**MWO 186-1**

**MODIFICATION WORK ORDER**

**MODEL 131**

**SELCAL SYSTEM**

Figure 1

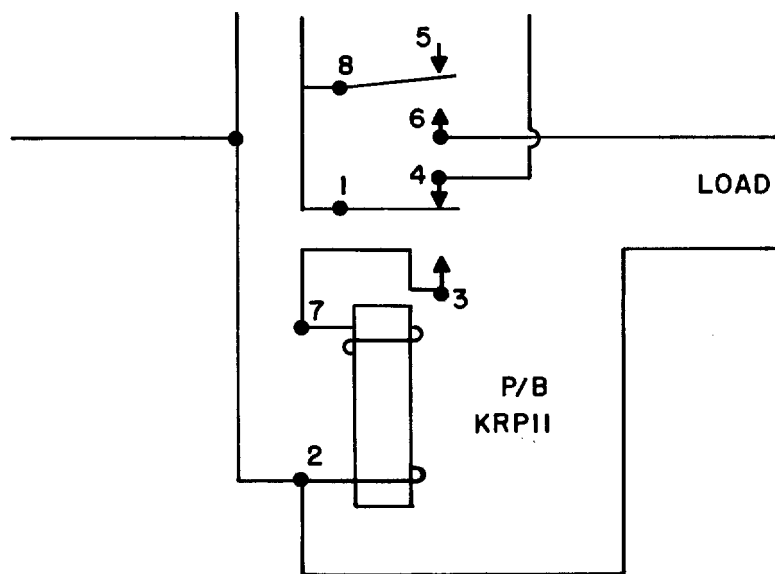
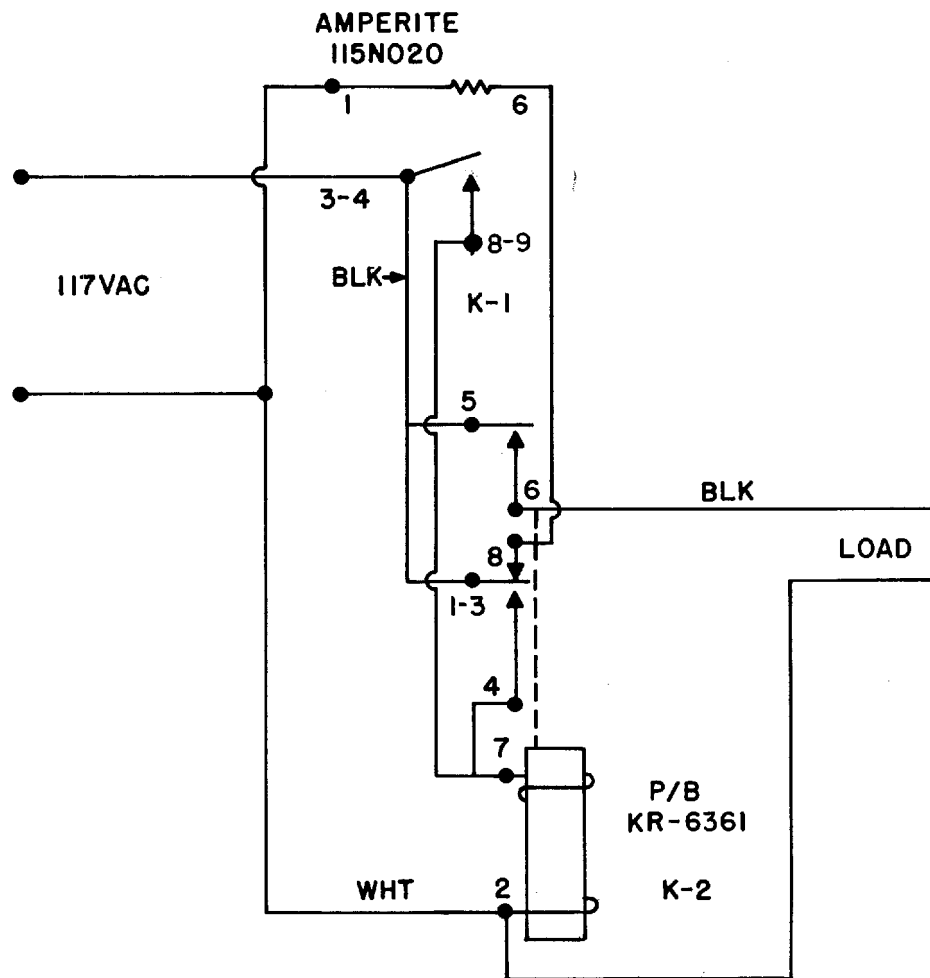
4.2 Remove the black AC wire from TB-2, Terminal 2. Cut off the lug and strip off 1/2" of insulation.

4.3 Solder this wire to pin 5 of the P/B KR-63<sup>6</sup>1 octal relay socket (Pin 8 of KRP11). (See Figure 1).

4.4 Connect the black wire from pin 6 of the octal relay socket to TB-2, Terminal 2. (See Figure 1).

4.5 Connect the white wire from pin 2 of the octal relay socket to TB-2, Terminal 3 together with the white wire of the AC cord.

Figure 2

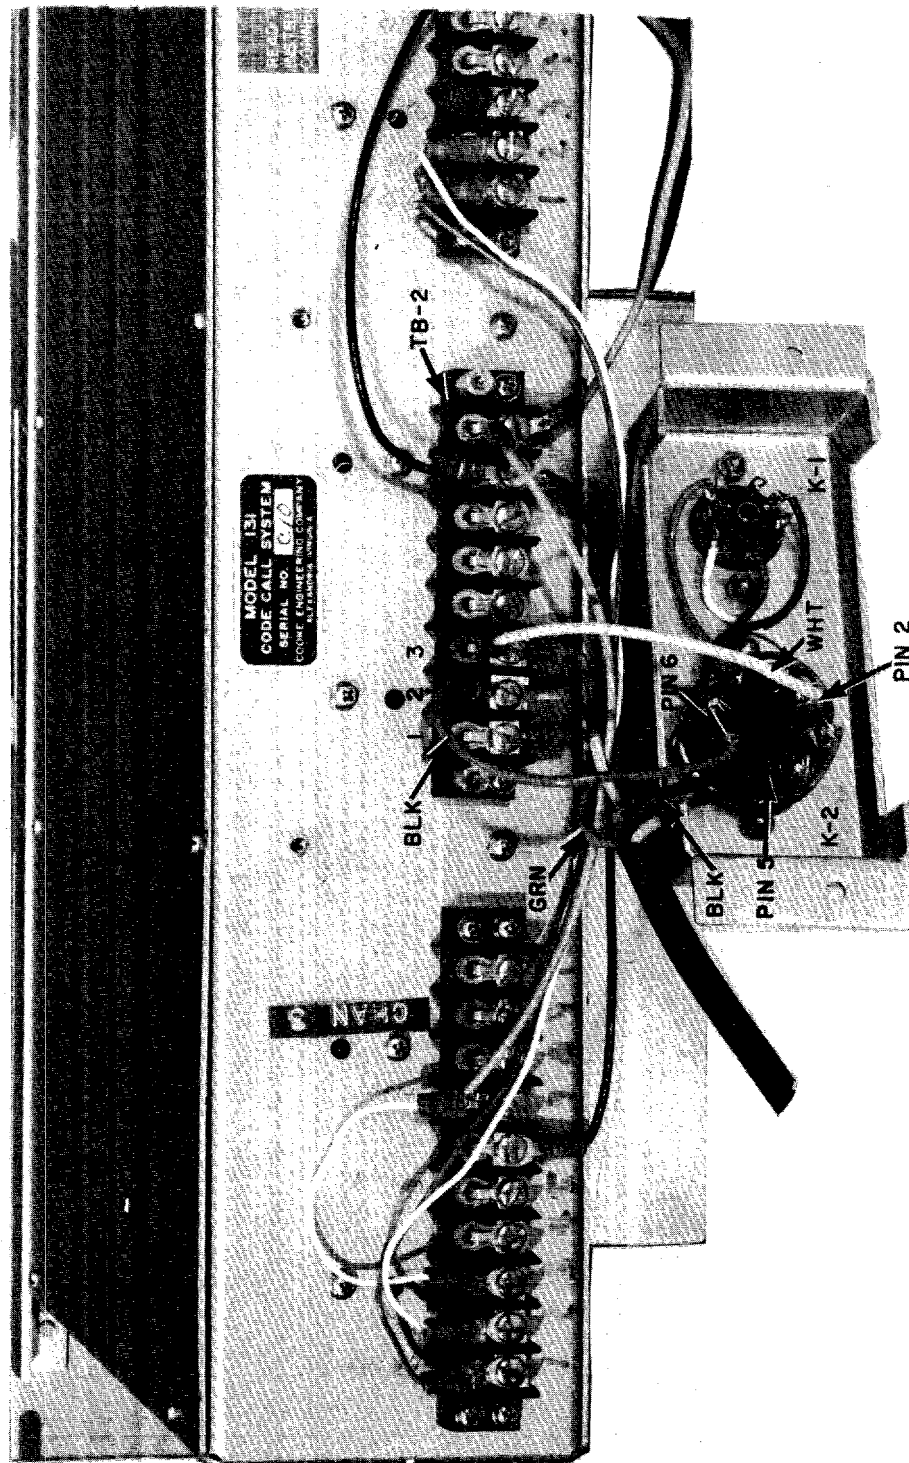
4.6 Attach the relay socket plate to the back of unit above TB-2.  
Utilize the two screws/holes already present (See Figure 2).
